BROWNS FERRY NUCLEAR PLANT (BFN) – UNITS 1, 2, AND 3 – TECHNICAL SPECIFICATIONS (TS) CHANGES TS-418 AND TS-431 – EXTENDED POWER UPRATE (EPU) – RESPONSE TO ROUND 23 REQUEST FOR ADDITIONAL INFORMATION (RAI) REGARDING STEAM DRYER SIGNAL PROCESSING (TAC NOS. MD5262, MD5263, AND MD5264)

**TENNESSEE VALLEY AUTHORITY
BROWNS FERRY NUCLEAR PLANT (BFN)
UNITS 1, 2, AND 3**

**TECHNICAL SPECIFICATIONS (TS) CHANGES TS-431 AND TS-418
EXTENDED POWER UPRATE (EPU)**

**RESPONSE TO ROUND 23 REQUEST FOR ADDITIONAL INFORMATION (RAI)
REGARDING STEAM DRYER SIGNAL PROCESSING**

Figure EMCB.203-1.1c: Autospectra of measured data for BFN1 main steam line C: upper strain gage location (top), lower strain gage location (bottom), for CLTP conditions (black) and corresponding EIC (red).

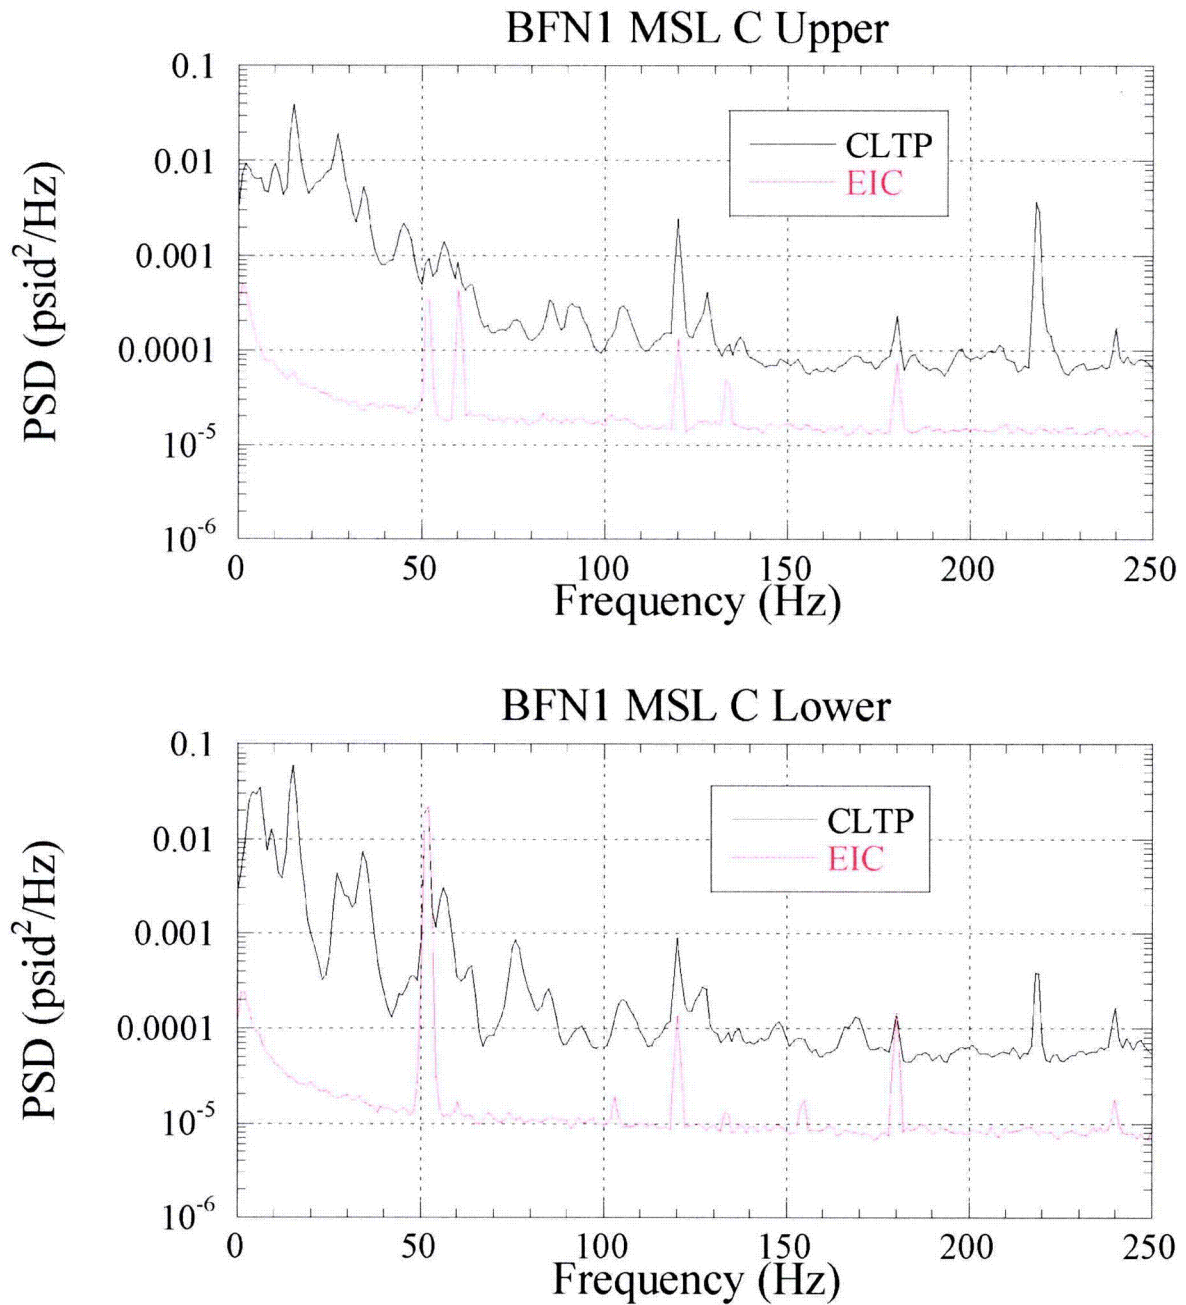
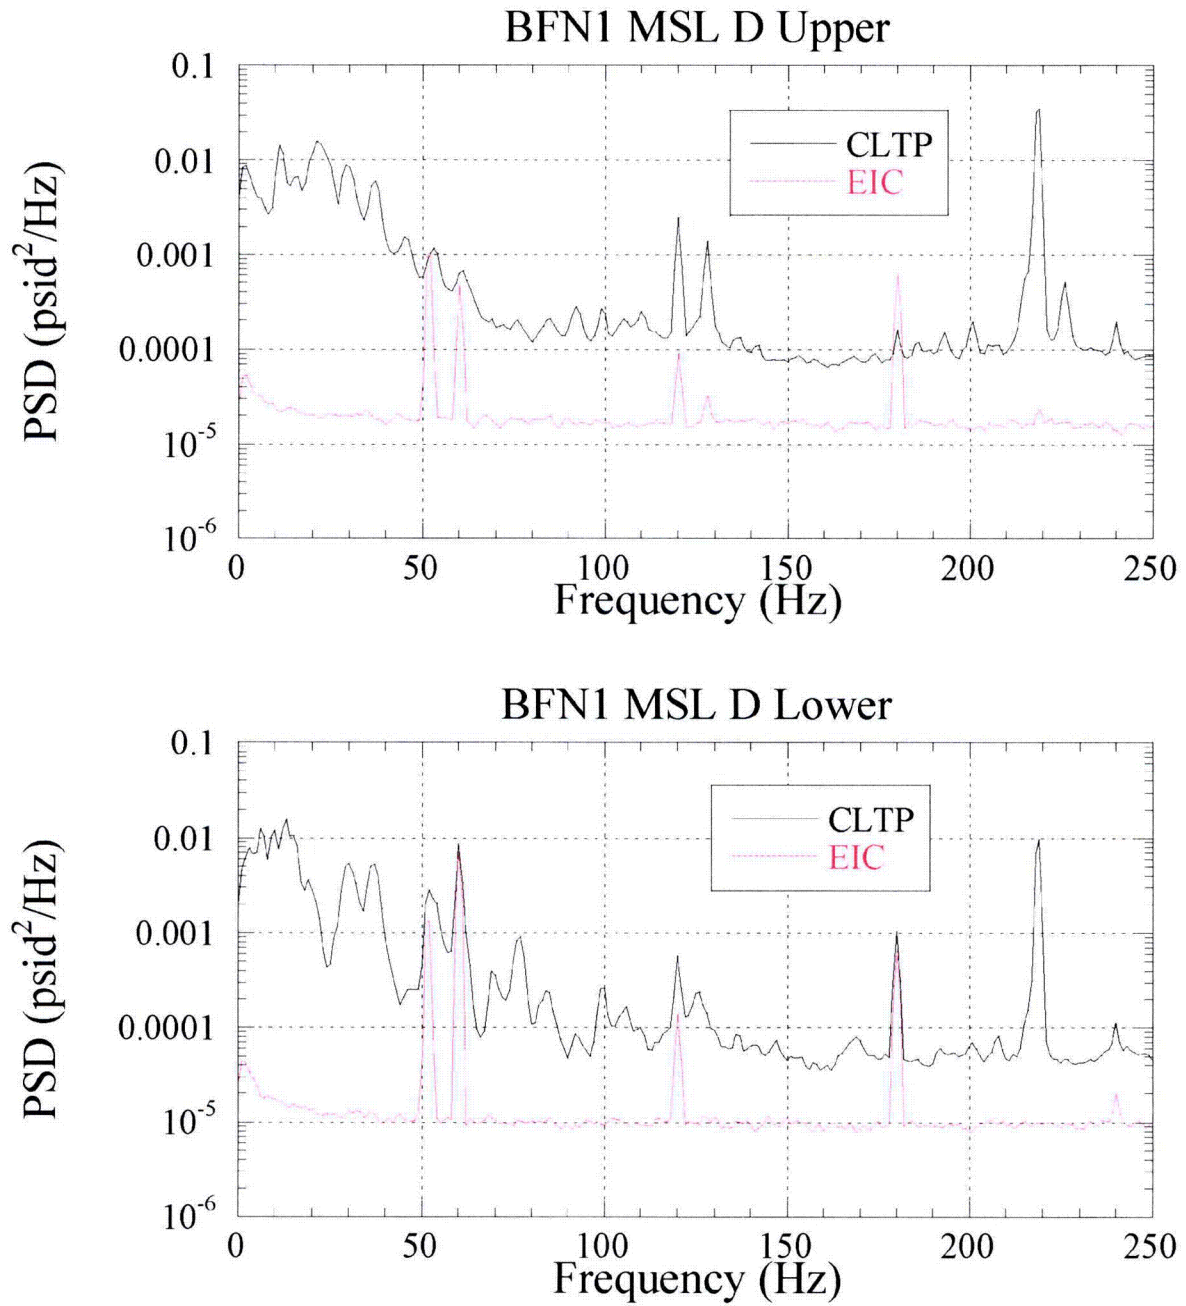
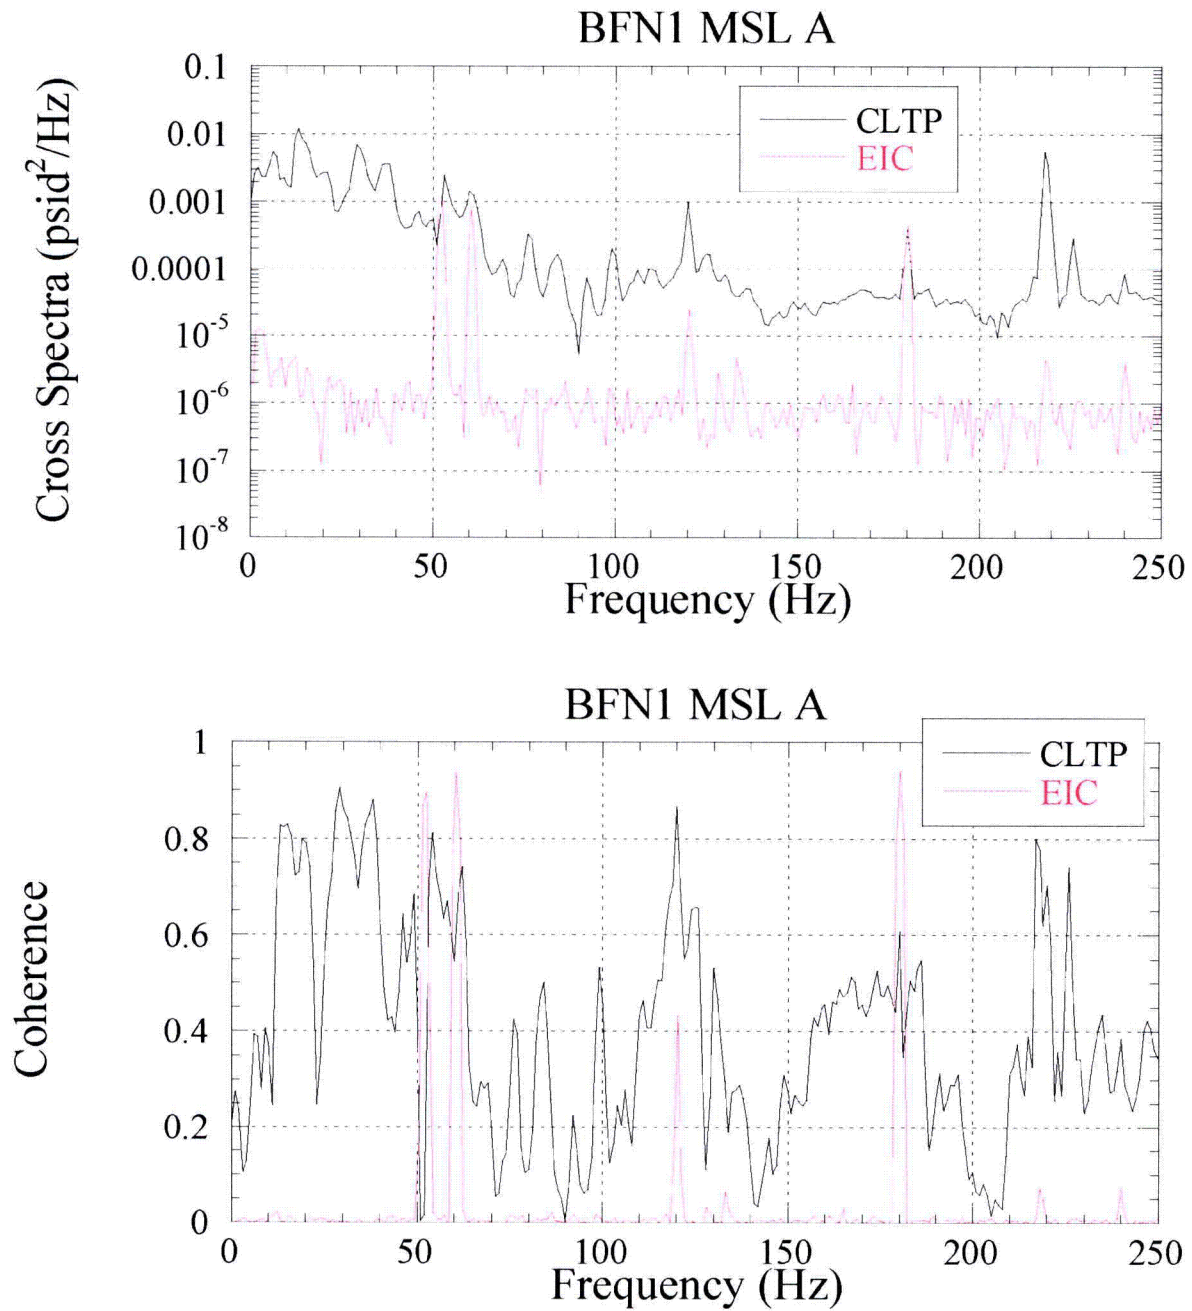
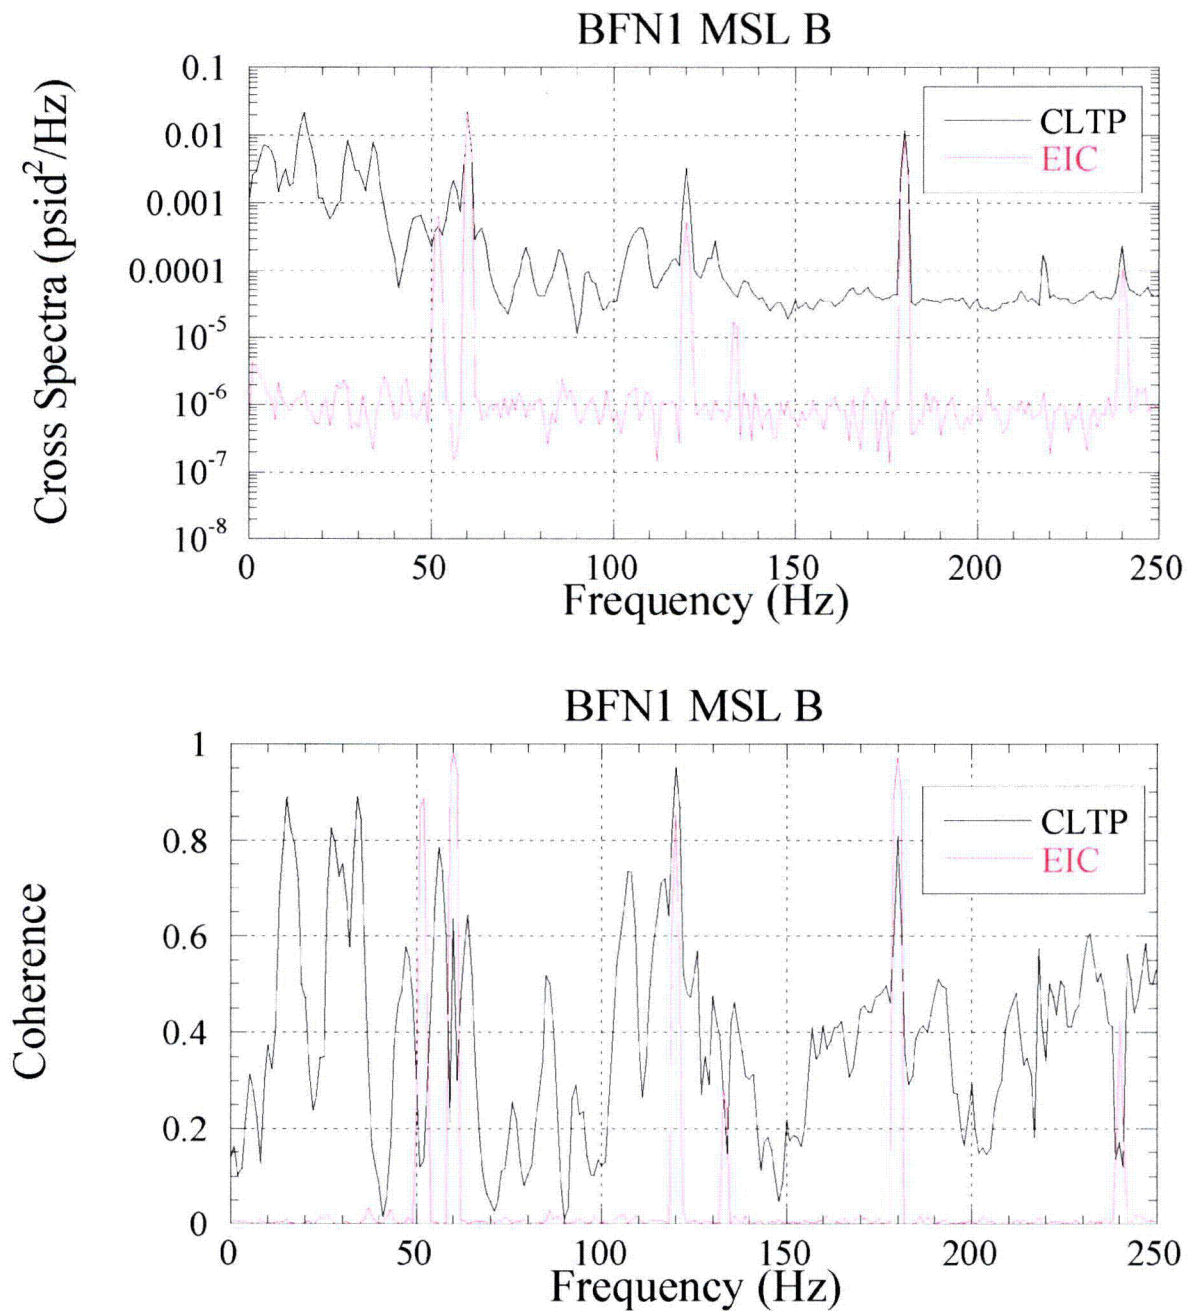
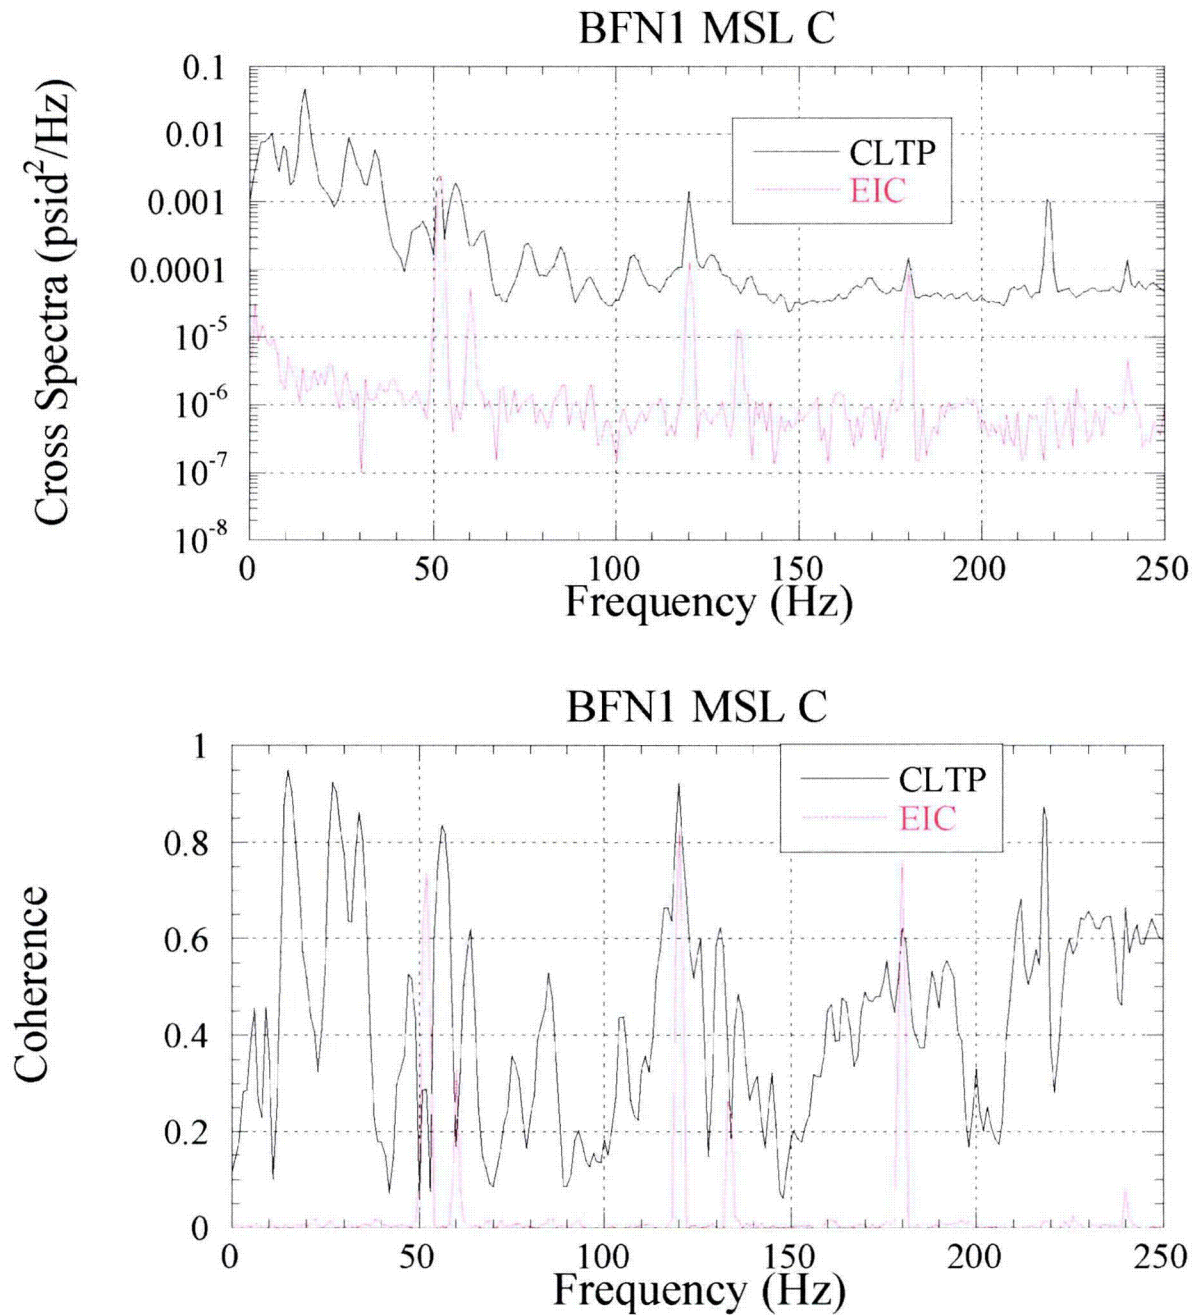
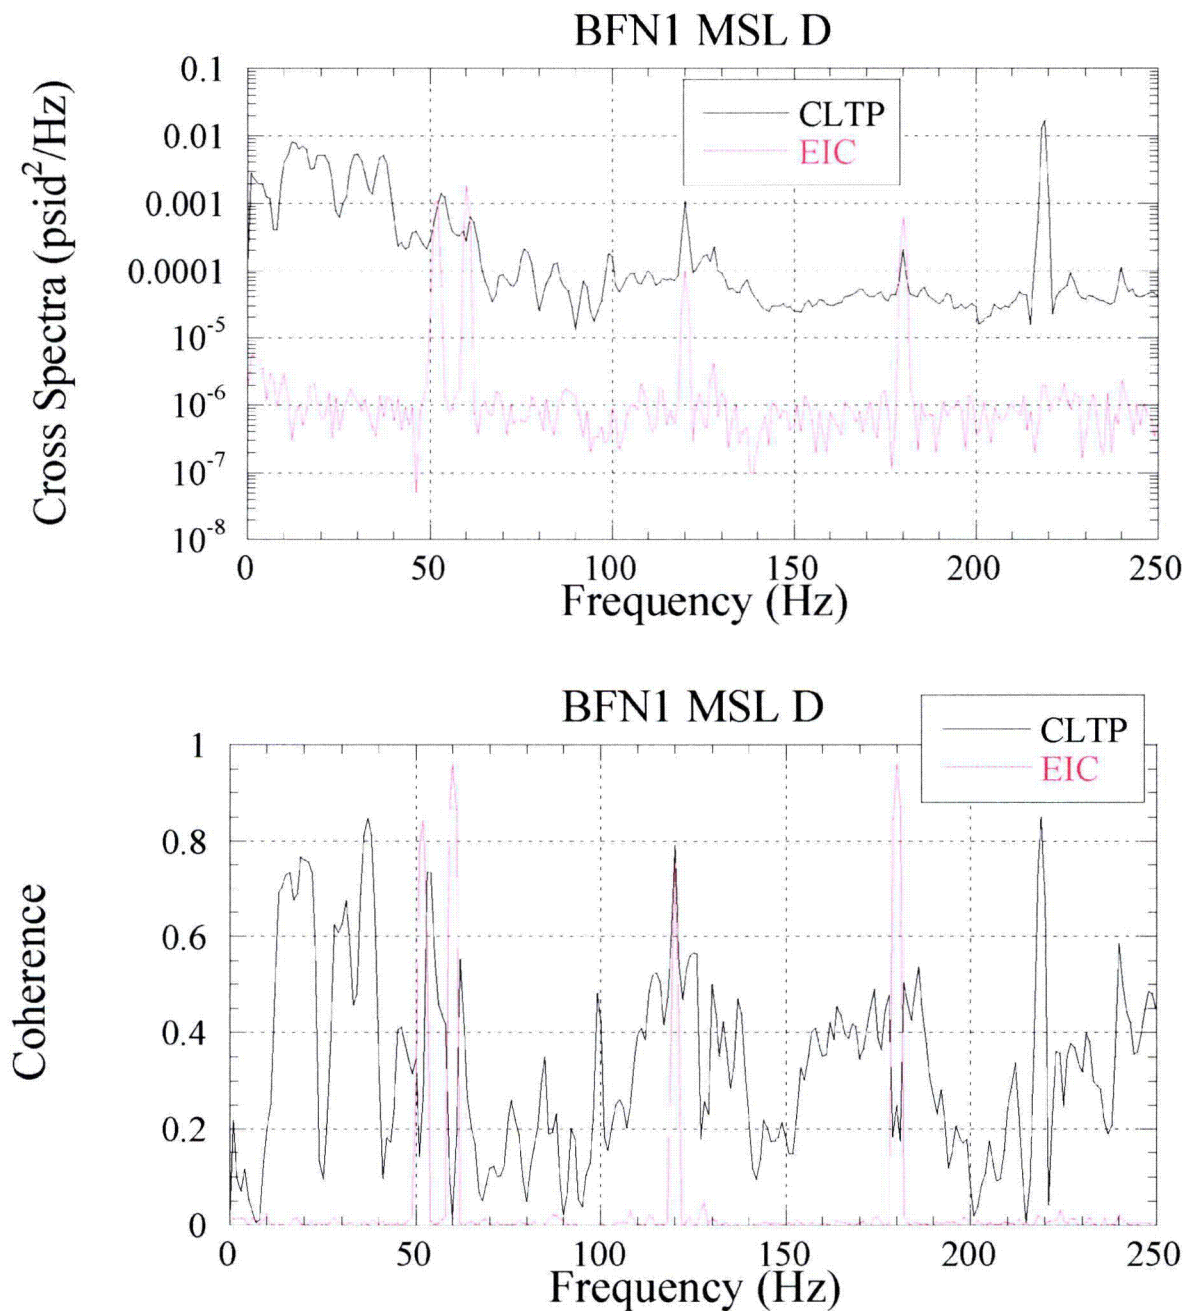
In response to EMCB.200/157., TVA presents detailed discussion of signal conditioning in six steps. Provide plots of strain gage signals (autospectra, cross spectra, coherence, and phase) and computed [[]] throughout the procedure described in their RAI response (prior to step 1, after step 1, after step 2, after step 4 and after step 6), for current license thermal power (CLTP) and Low Flow (LF) signals, for Units 1 and 2.

The requested plots for Unit 1 are listed and provided below. The requested plots for Unit 2 are scheduled to be provided by January 23, 2009.
